ADDENDUM NO. 4

DATE: 1/29/2024

Porterville College Sports Complex (PC Baseball/ Softball Field)
100 E College Ave,
Porterville, CA 93257

DARDEN PROJECT NO. 2118
DSA File Nos. 03-122694
DSA APPL. NO. 15-C1

APPENDIX "C": EXTERIOR COLOR SCHEDULE AD-4

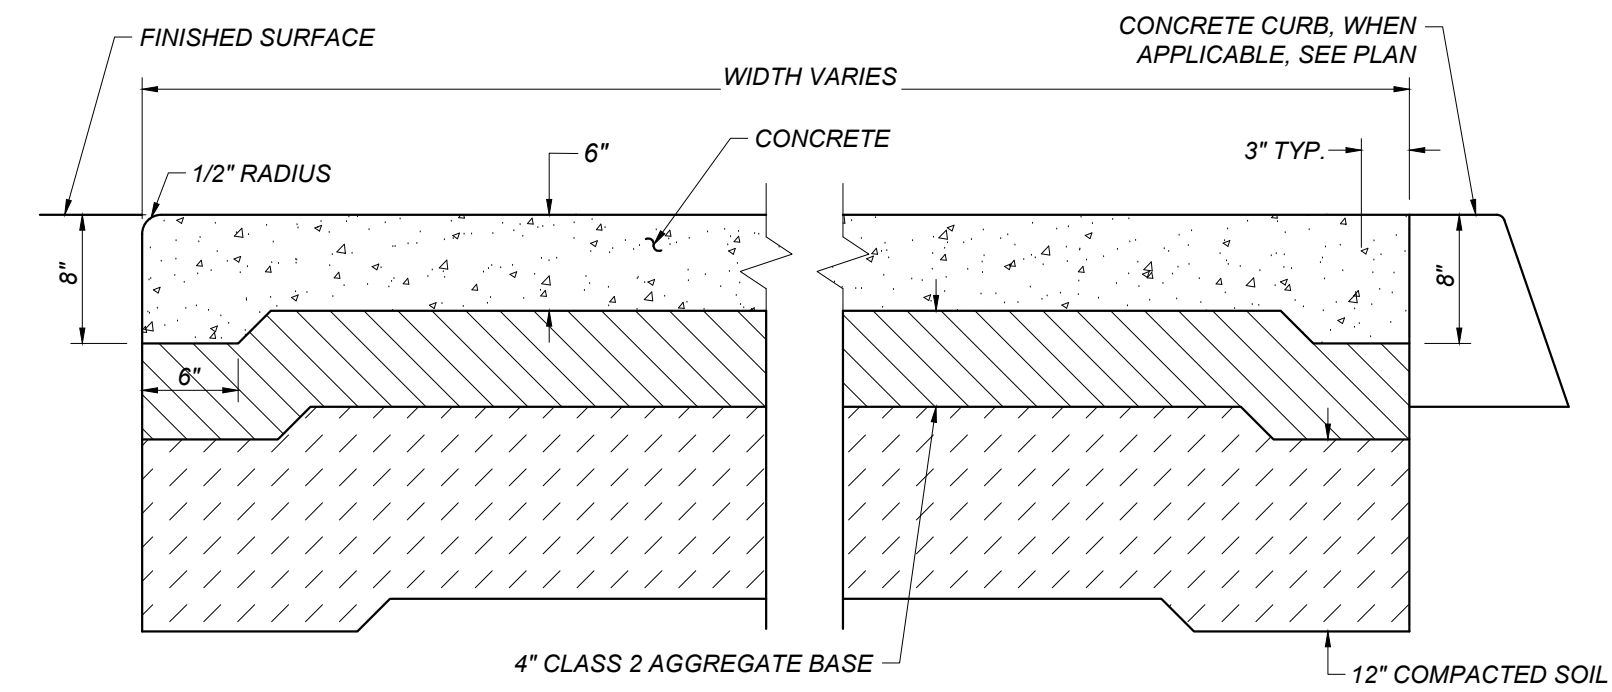
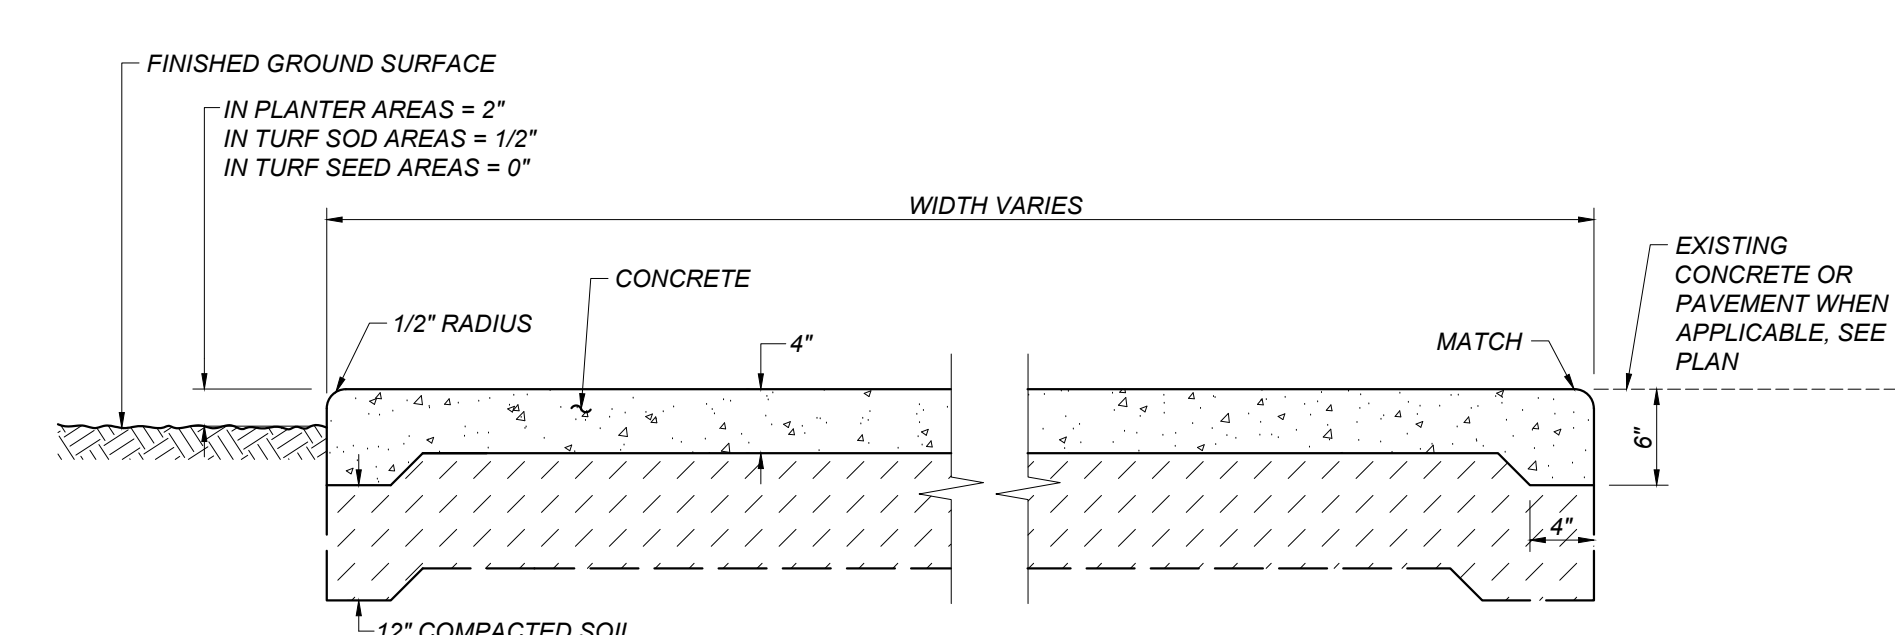
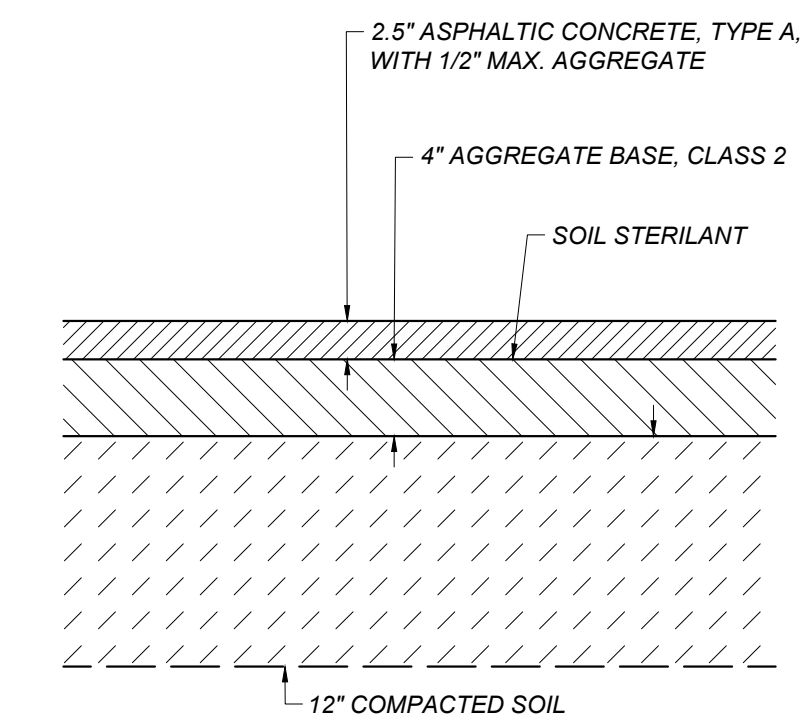
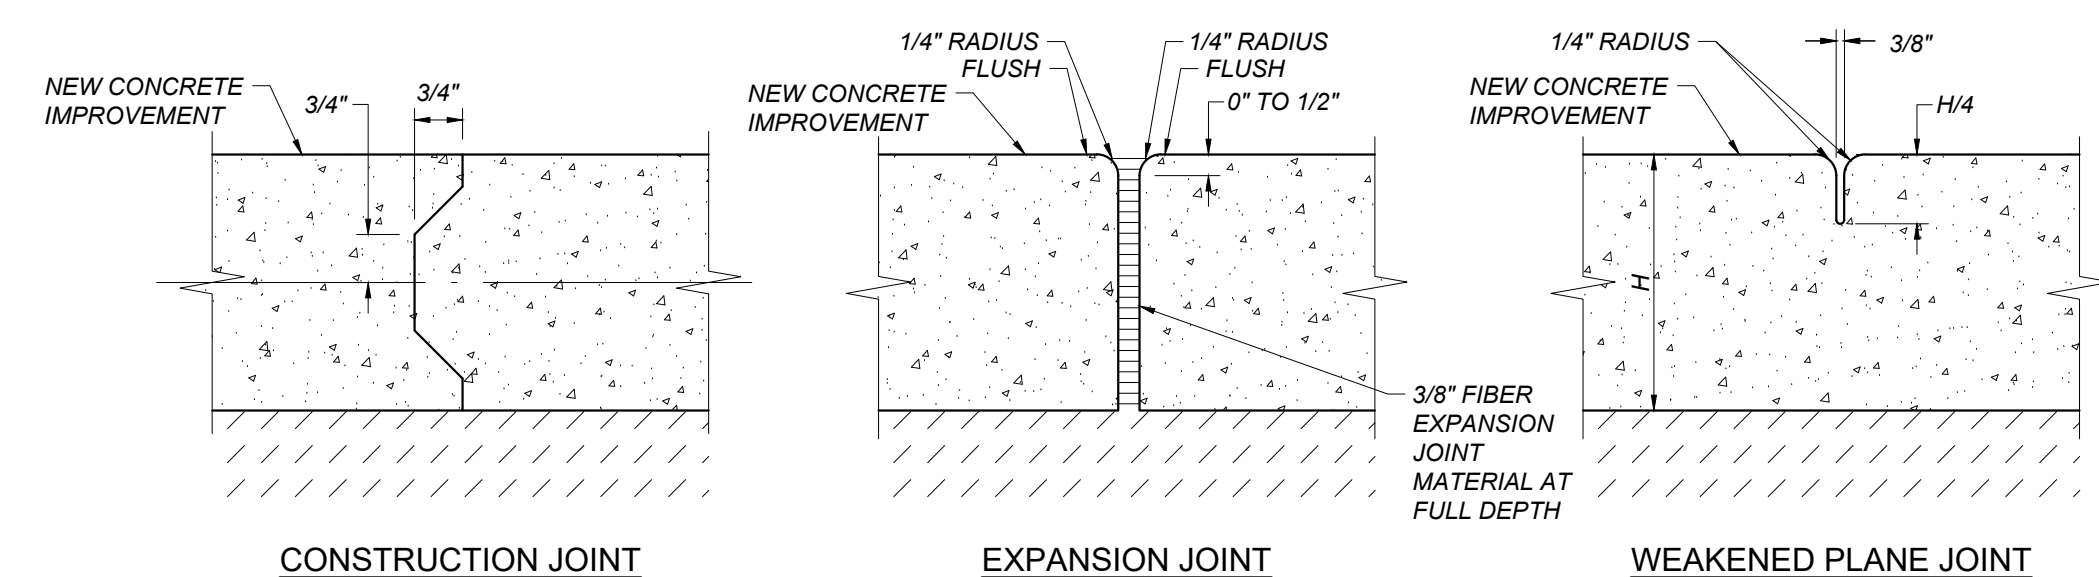
AD4-SP01 Refer to APPENDIX C, EXTERIOR COLOR SCHEDULE:

1. Replace APPENDIX C EXTERIOR COLOR SCHEDULE with the attached EXTERIOR COLOR SCHEDULE-AD4

I BASE BID BATTING CAGE SURFACING
SD/X101 NOT TO SCALE

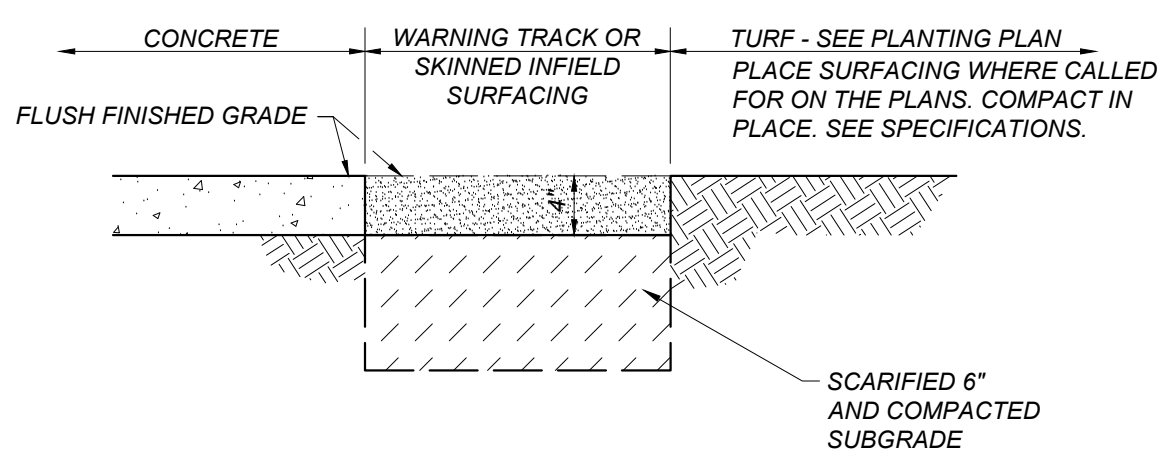
AD4-C01 Refer to Sheet SD/X101 and attached sheet AD4-CX01

1. Detail "I" has been removed.
2. Detail "J" has been removed

A BATTING CAGE SOFTBALL AND BASEBALL
SD/X601 NOTE: THIS DETAIL IS EXEMPT FROM DSA REVIEW PER DSA IR-A22 APPENDIX ITEM 23 AND IS NOT PART OF THIS DSA APPROVAL

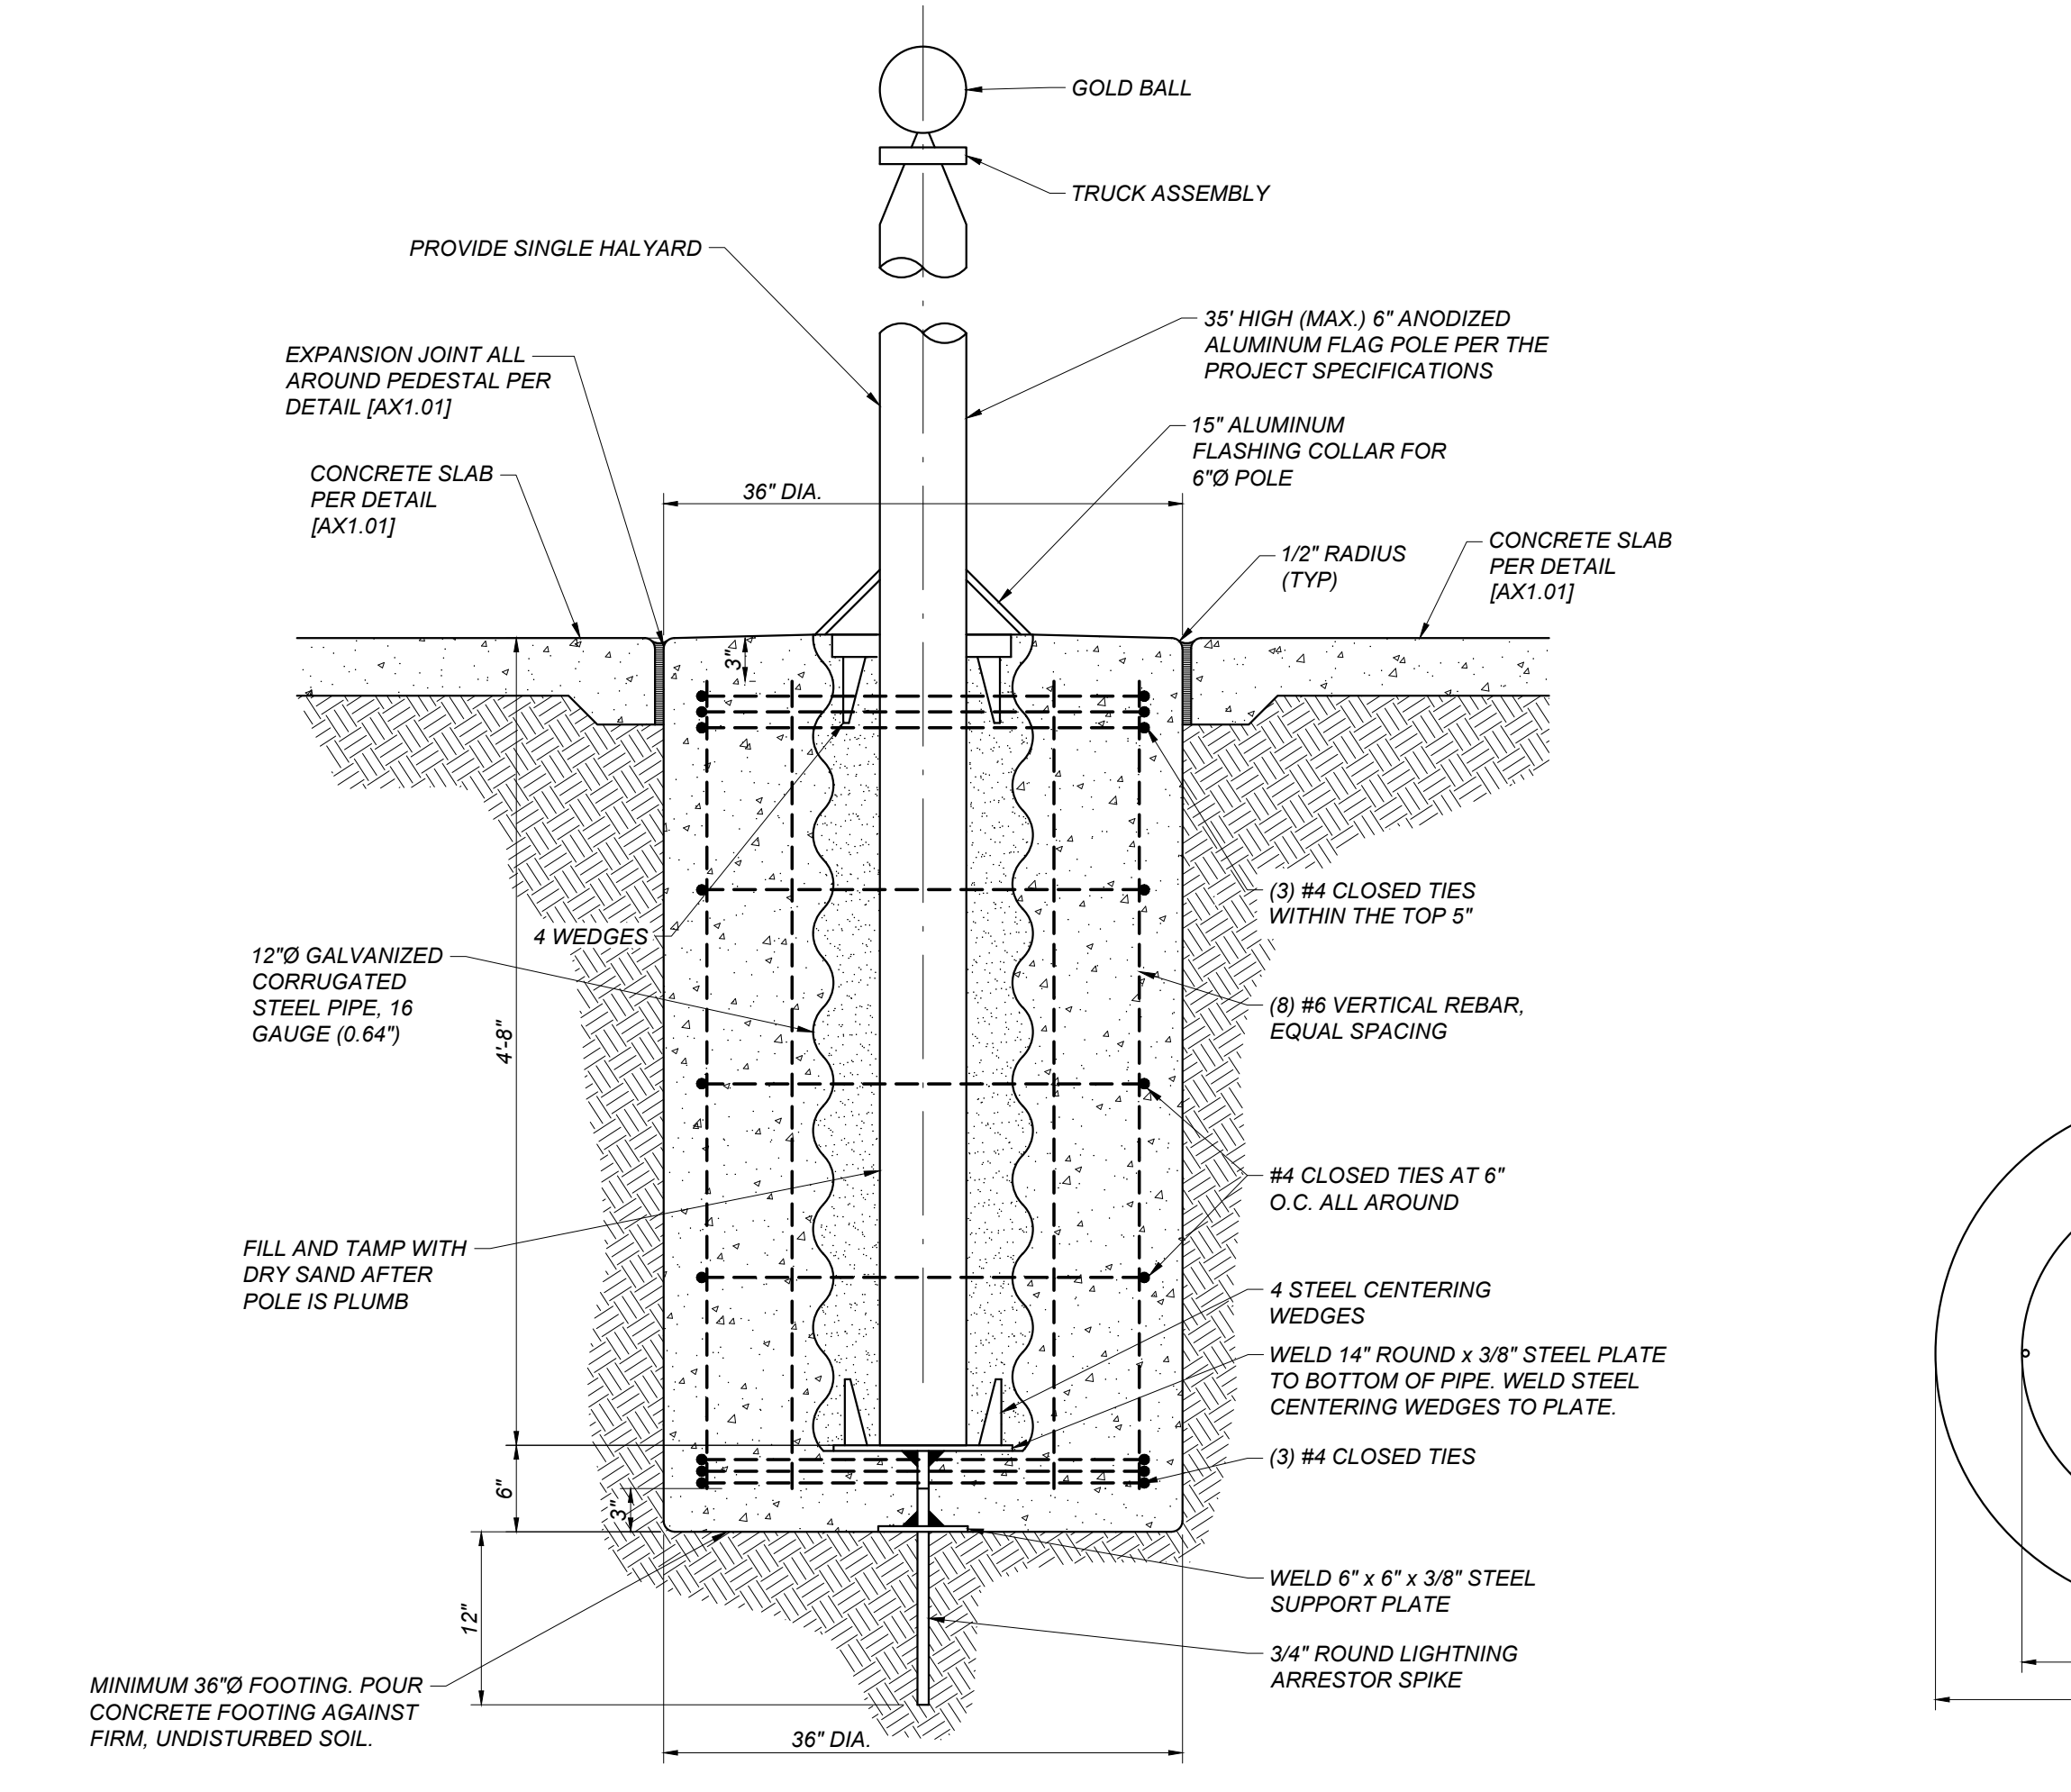
AD4-CPA02 Refer to Addendum No.2 Item AD2-C17 and Attached Addenda Sheet AD4-CX02:

1. Replaces sheet SD/X601-AD2-CX17 with the attached sheet SD/X601-AD4-CX02
2. Detail reference on detail A has been revised
3. Note 7 on "Notes on Batting Cage" has been revised
4. Note 8 on "Notes on Batting Cage" has been revised

6. BATTING CAGE PROVIDED BY CONTRACTOR AND INSTALLED PER MANUFACTURER'S RECOMMENDATIONS - SEE SPECIFICATIONS.
 7. IF THE SYNTHETIC TURF BID ALTERNATE IS ACCEPTED, CONCRETE SLAB SHALL BE LINED WITH BEACON ATHLETICS 36 OZ POLYPROPYLENE URETHANE BACKING TO MATCH BATTING CAGE DIMENSION, OR APPROVED EQUAL.

8. IF THE SYNTHETIC TURF BID ALTERNATE IS REJECTED, REFER TO DETAIL (B/SDX101) FOR BASE BID BATTING CAGE SURFACING.
